SUBJECT: Forwards addl info re 801201 request for amend of License DPR-23 to expand spent fuel pool storage. Effects of increased loads on fuel pool liner & structures provided. Replacement pages to 801201 submittal attached.

H. B. ROBINSON STEAM ELECTRIC PLANT UNIT NO. 2
DOCKET NO. 50-261
LICENSE NO. DPR-23
REVISION TO REQUEST FOR LICENSE AMENDMENT
SPENT FUEL POOL STORAGE EXPANSION

FUEL POOL
STRUCTURAL MODIFICATIONS

6-1

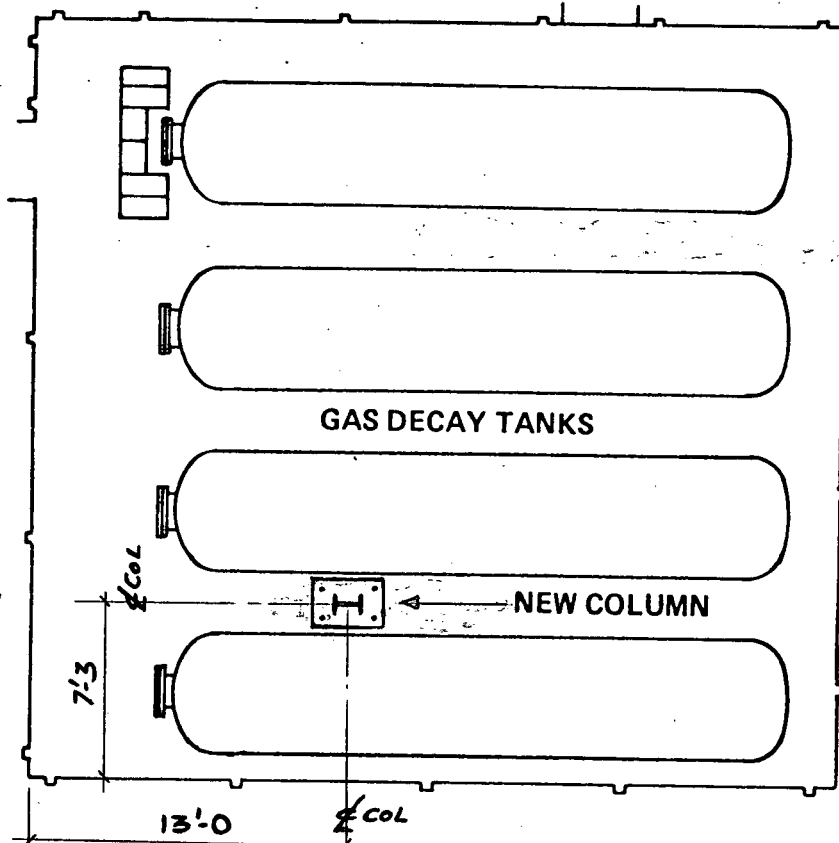
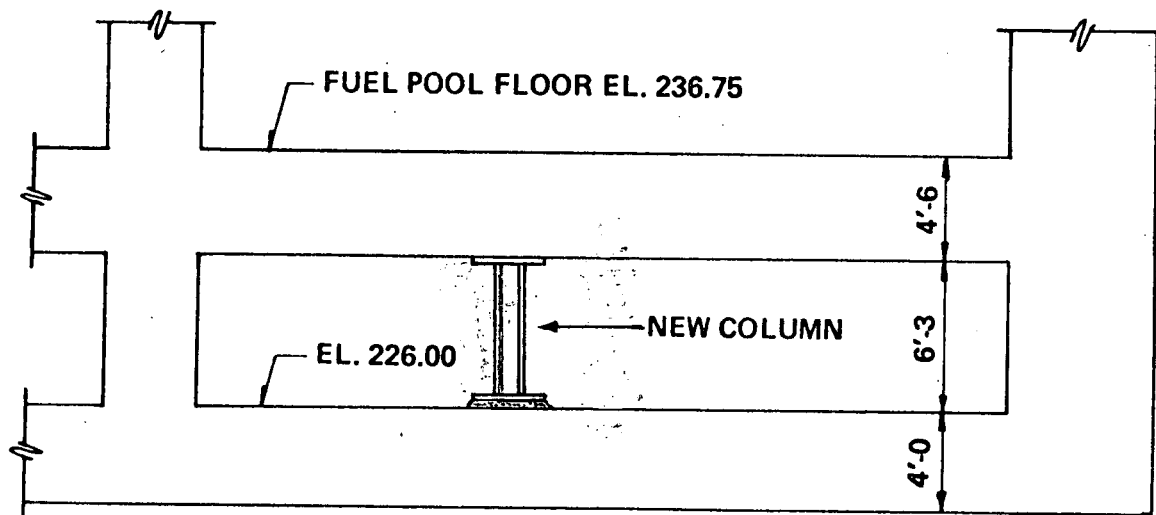
- a. Revised paragraphs for Section 4.4 to reflect completion of the final seismic analysis.
- b. Revised paragraph for Section 6.0 to show the need for only one column to support the fuel pool floor.
- c. Revised Figure 6-1 showing location of the single column.

It will be necessary to provide additional support for the fuel pool floor. This will be accomplished by provision of one structural steel column in the gas decay tank storage room which is below the fuel pool. Column configuration is indicated in Figure 6-1. The column will transmit its load to the existing building slab and will be installed utilizing drilled-in anchor bolts and non-shrink grouting beneath the column base plate. Stressing the column is expected to be accomplished by lowering the water level in the pool approximately seven (7) feet during installation. After installing the column, the pool will be returned to normal water level to accomplish the required post stress. This work will be done prior to any increase in the load.

The final investigation shows that with the addition of one steel column under the fuel pool floor, as described in Section 6.0, the structure will have adequate capacity to carry the increased loads imposed by the new high density spent fuel storage racks.
